ATTACHMENT No. 2 to AEP:NRC:0564

A modification was made to the high pressure turbine in Unit 2 during the current refueling outage to improve overall turbine efficiency. The current Technical Specification setpoint for the P-7 permissive in the logic of the Reactor Protection System (RPS) is low and needs to be increased to the new value of the first stage turbine impulse chamber pressure corresponding to 10% power (66 psia). Our calculations indicate that the current P-7 setpoint may cause unnecessary tripping of the reactor since Reactor Trip from a Turbine Trip could occur during the turbine overspeed tests with the current (low) setpoint of the impulse chamber pressure. Raising the setpoint of the P-7 permissive to 66 psia will avoid possible unnecessary reactor trips, is consistent with the FSAR value for Reactor Trip/Turbine Trip at or above 10% power, and will not adversely affect the health and safety of the public.

FIGURE 3.2-1 AXIAL FLUX DIFFERENCE LIMITS AS A FUNCTION OF RATED THERMAL POWER

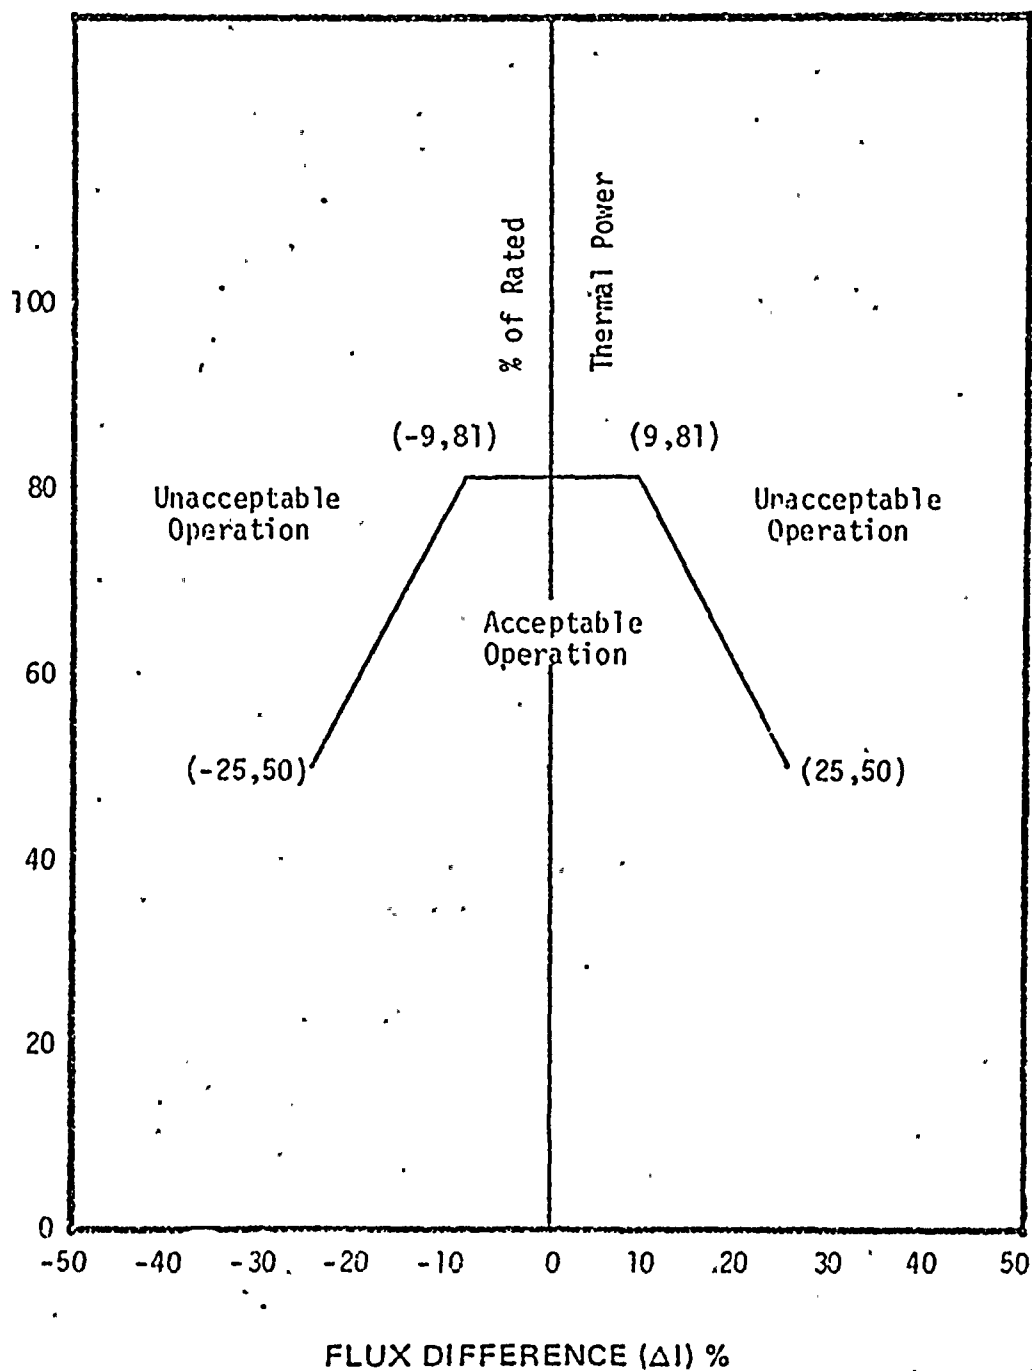
- 2) The indicated AFD is within the limits shown on Figure 3.2-1. Otherwise, reduce THERMAL POWER to less than 50% of RATED THERMAL POWER within 30 minutes and reduce the Power Range Neutron Flux-High Trip Setpoints to $\leq 55\%$ of RATED THERMAL POWER within the next 4 hours.

- b) Surveillance testing of the Power Range Neutron Flux Channels may be performed pursuant to Specification 4.3.1.1.1 provided the indicated AFD is maintained within the limits of Figure 3.2-1. A total of 16 hours operation may be accumulated with the AFD outside of the target band during this testing without penalty deviation.

- c) Surveillance testing of the APDMS may be performed pursuant to Specification 4.3.3.7.1 provided the indicated AFD is maintained within the limits of Figure 3.2-1. A total of 6 hours of operation may be accumulated with the AFD outside of the target band during this testing without penalty deviation.
- b. THERMAL POWER shall not be increased above 81% of RATED THERMAL POWER unless the indicated AFD is within the $\pm 5\%$ target band and ACTION 2.a) 1), above has been satisfied.
- c. THERMAL POWER shall not be increased above 50% of RATED THERMAL POWER unless the indicated AFD has not been outside of the $\pm 5\%$ target band for more than 1 hour penalty deviation cumulative during the previous 24 hours.
